# Work Order ID 74243

Item Name: Crosstube Turning Detail

<b>DART AEROSPACE LTD</b>		<b>Work Order:</b> 74243
<b>Description:</b> Crosstube Assembly (205/212 Low Aft)		<b>Part Number:</b> D212-664-247
<b>Inspection Dwg:</b> D212-664-247 <b>Rev:</b> B		<b>Page 1 of 1</b>

DRAWING NO. D212-664-247	TITLE CROSSTUBE ASS'Y (205 LOW AFT)	REV. B	<b>DART AEROSPACE LTD ENGINEERING ORDER</b>		D.E.O. NO. D212-664-247-B-1	SHEET NO. SHEET 1 OF 1	SCALE NTS
DRAWN <i>q</i>	CHECKED <i>ASS</i>	MFG. APPR. <i>AB</i>	APPROVED <i>WD</i>		DE APPR. <i>AB</i>		
DATE 11.07.15	DATE <i>11.07.20</i>	DATE <i>11.07.21</i>	DATE <i>11/07/21</i>		DATE <i>11.07.21</i>

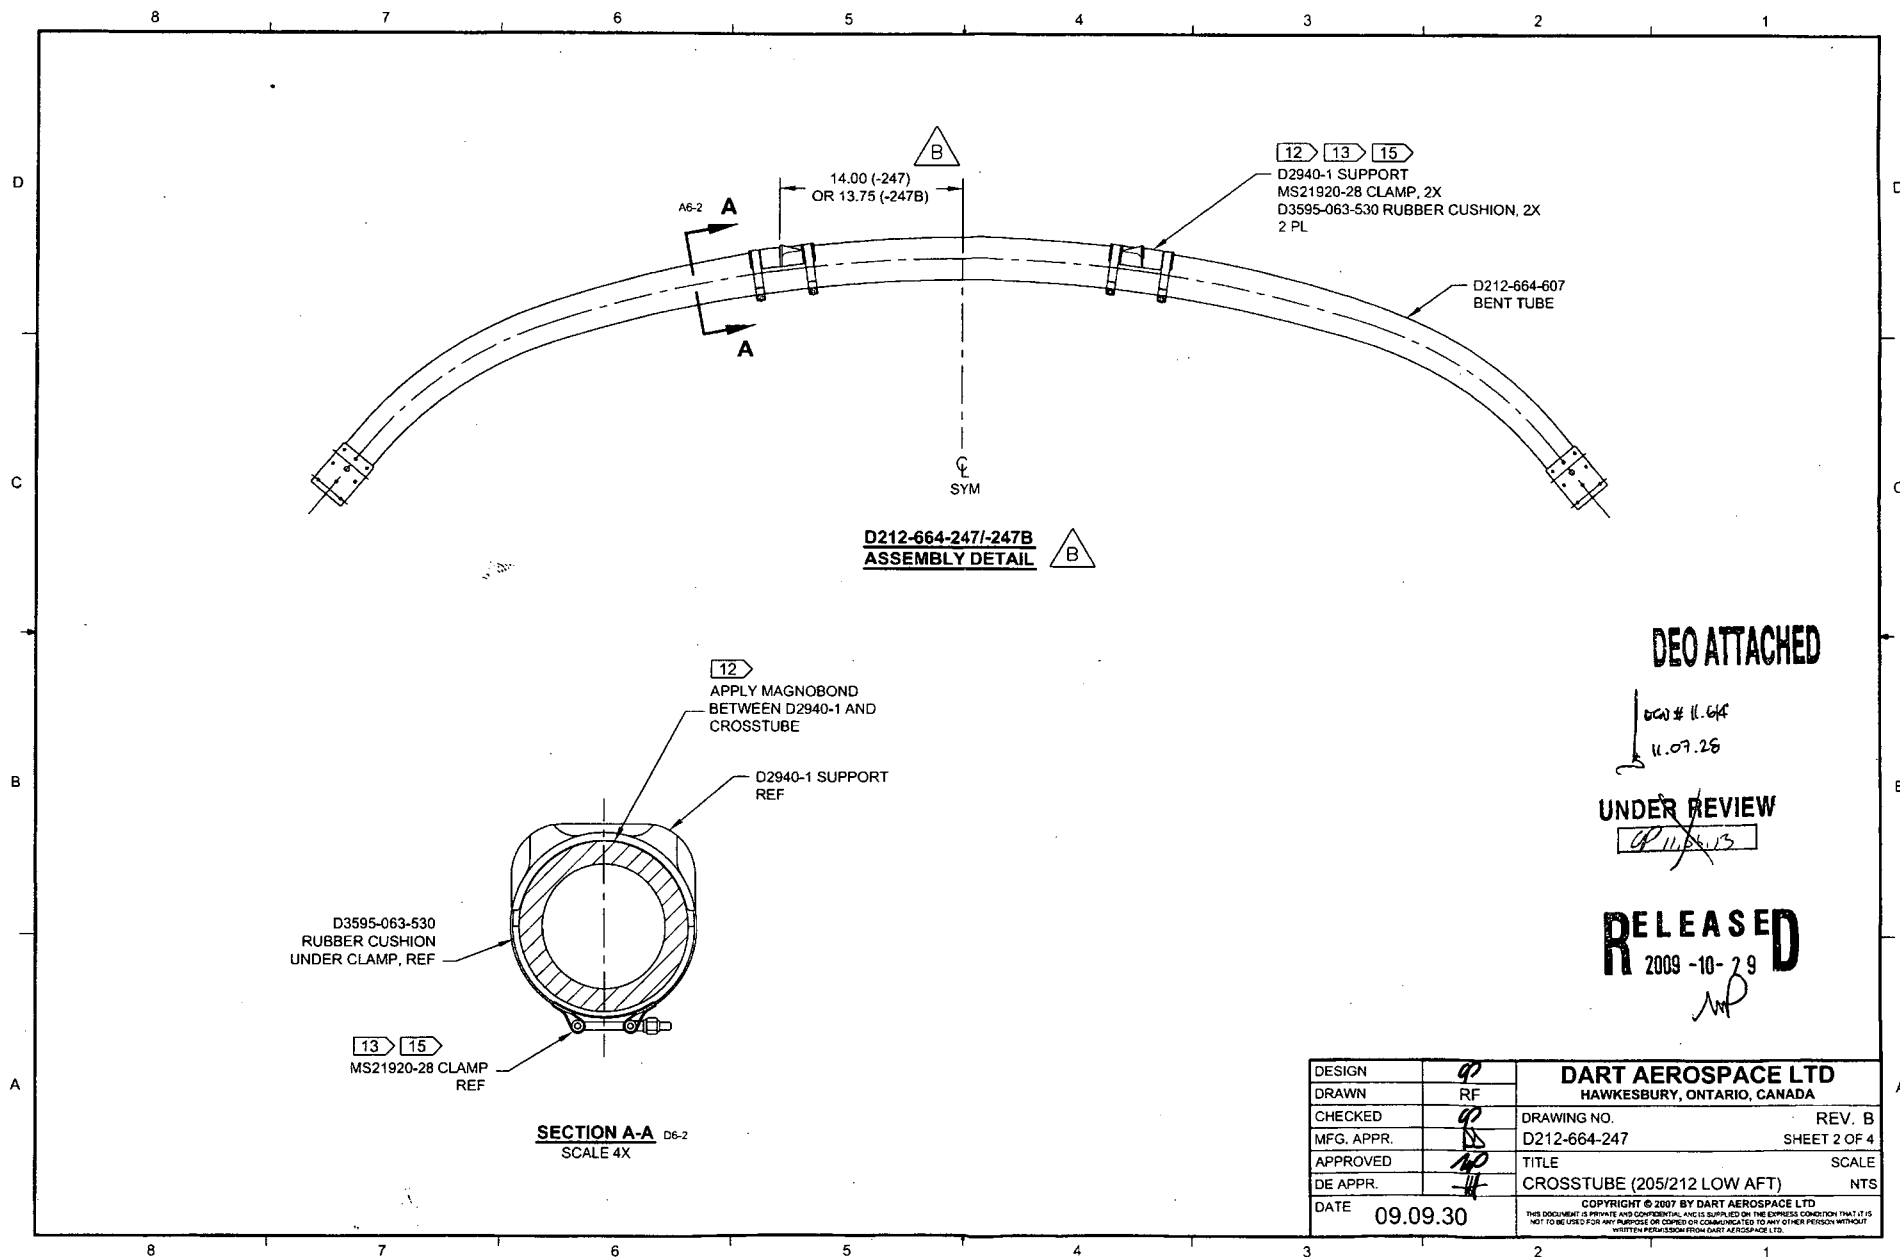
**PURPOSE:**

REPLACE MAGNOBOND WITH PROSEAL

NOTE 12 & 15, SHEET 1 IS AMENDED AS FOLLOWS:

Item	Qty -247	Qty -247B	Part Number	Description
9	A/R	A/R	PROSEAL 890 B-2	SEALANT, AMS-S-8802 CLASS B-2

9	A/R	A/R	MAGNOBOND 6398	ROCKWELL SPECIFICATION RBO-120-023 ADHESIVE (TEXTRON/BELL SPEC. 299-947-100, TYPE II, CLASS 2 ADHESIVE)
---	-----	-----	----------------	---

- 12) TO INSTALL D2940-1 SUPPORT: ABRASE MATING SURFACE OF SUPPORT AND CROSSTUBE WITH 180-GRIT SANDPAPER AND REMOVE RESIDUE WITH MEK (OR EQUIVALENT). APPLY A 0.04" TO 0.07" THICK LAYER OF PROSEAL 890 CLASS B-2 (OR AMS-S-8802 CLASS B-2) SEALANT TO MATING SURFACE OF SUPPORT.
- 15) TORQUE CLAMPS 80 TO 100 IN-LB. ENSURE AT LEAST 1.5 THREADS SHOWING IN SAFETY AND THAT NUT HAS NOT BOTTOMED-OUT AFTER TORQUING. **PRIOR TO PACKAGING, RE-CHECK TORQUE ON CLAMPS AFTER PROSEAL 890 SEALANT HAS CURED FOR 72 HOURS.**

- 12) INSTALL D2940-1 SUPPORT USING 0.03" TO 0.06" THICK LAYER OF MAGNOBOND 6398 TO THE SURFACE OF D2940-1 THAT WILL BE IN CONTACT WITH THE CROSSTUBE PER QSI 015. LET CURE FOR 12 HOURS AFTER INSTALLATION AND PRIOR TO PACKAGING.
- 15) TORQUE CLAMPS 80 TO 100 IN-LB. ENSURE AT LEAST 1.5 THREADS SHOWING IN SAFETY AND THAT NUT HAS NOT BOTTOMED-OUT AFTER TORQUING.
